RE: 4615-XXX - RFP 01 – Replace Sullivan Frames

F.H. Paschen has agreed to the following scope of work with Prospect Heights School District 23. We are pleased to present the following scope of work for your review.

WINDOW AND SIDING REPLACEMENT PHASE 2

Sketch Number:
ASK-006R1

SULLIVAN PARTIAL FIRST FLOOR DEMOLITION PLAN

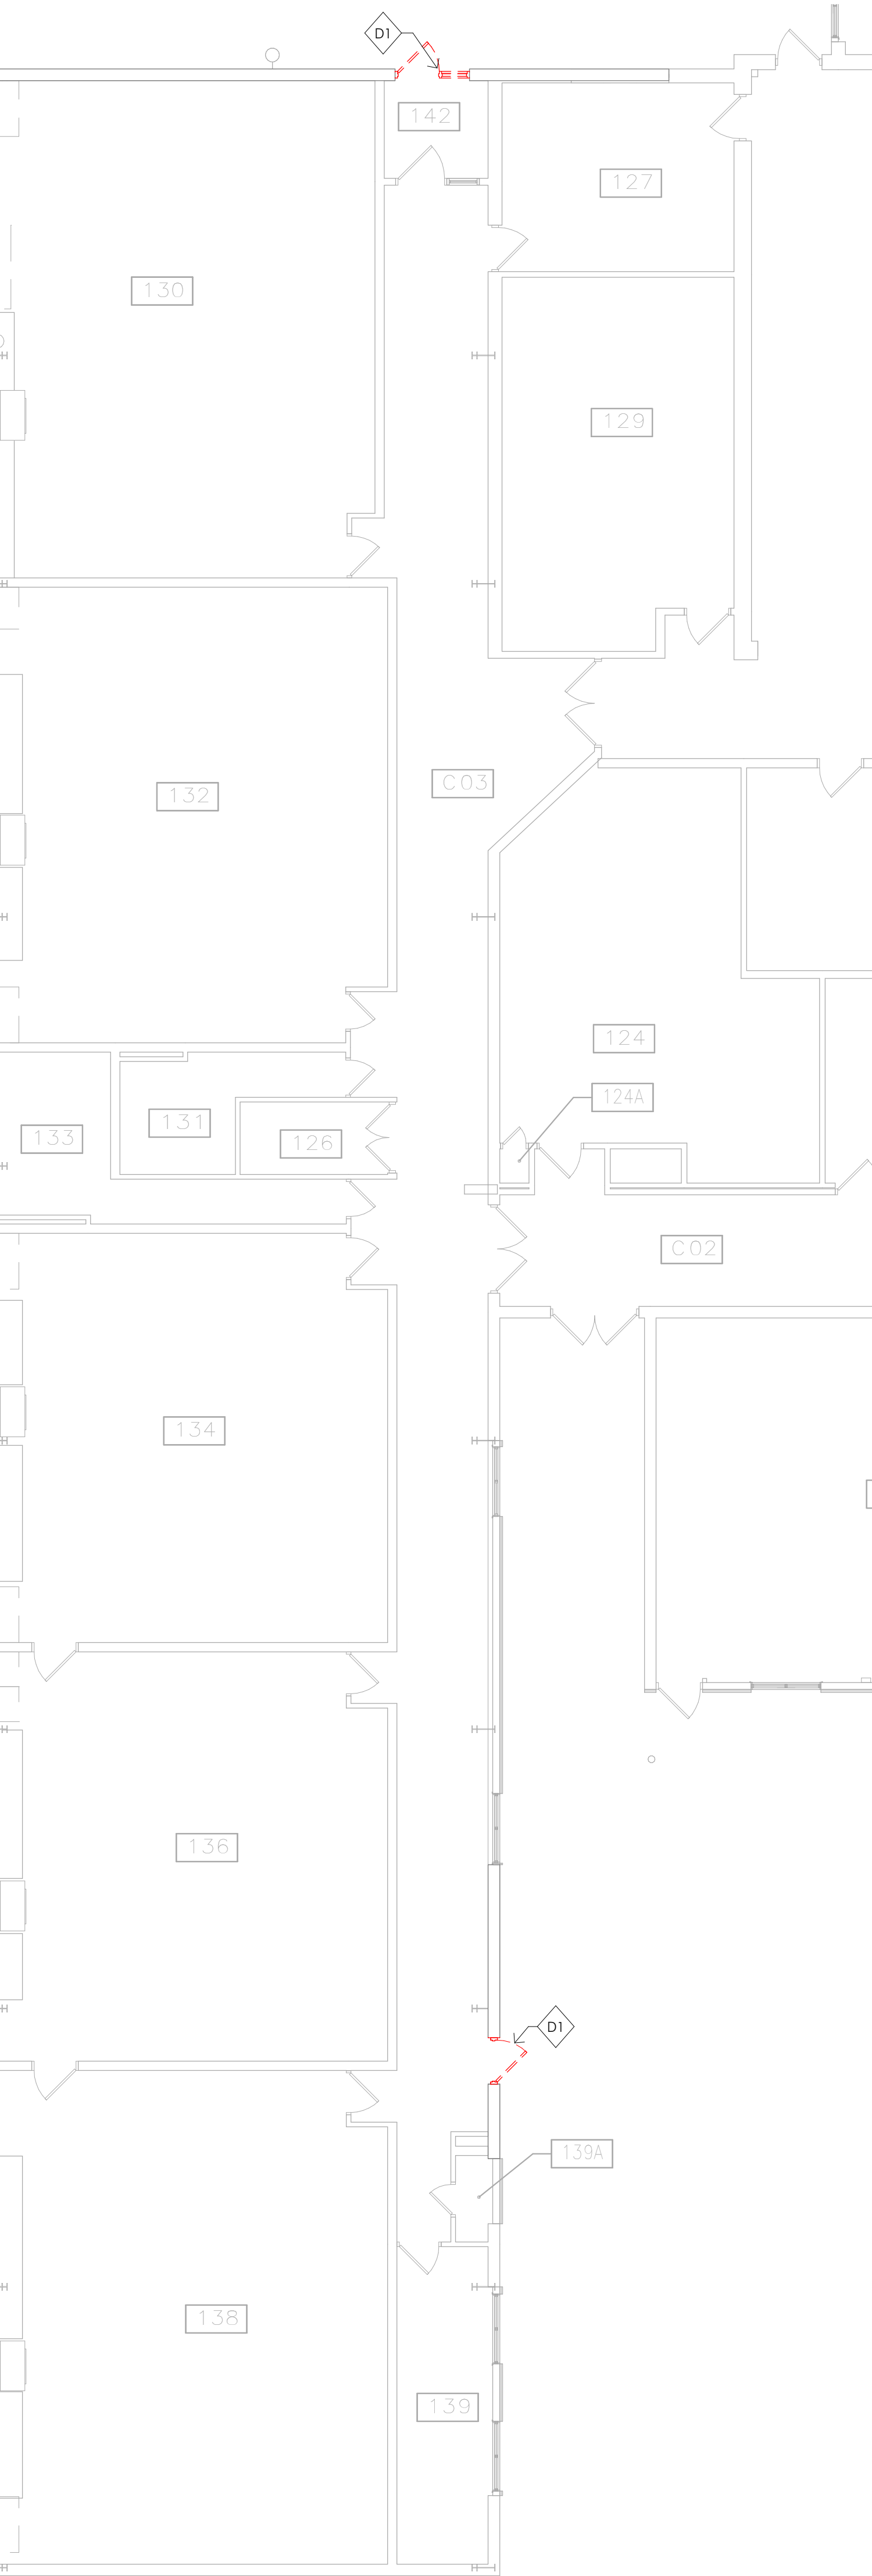
D1 **DOOR:** REMOVE & DISPOSE OF EXISTING FRAME AND FRAME GLAZING ONLY. REMOVE AND SALVAGE DOOR LEAF AND ALL HARDWARE FOR RE-INSTALLATION.

G1 **DOOR:** INSTALL NEW DOOR FRAME, NEW FRAME GLAZING, SALVAGED DOOR LEAF, AND SALVAGED HARDWARE.
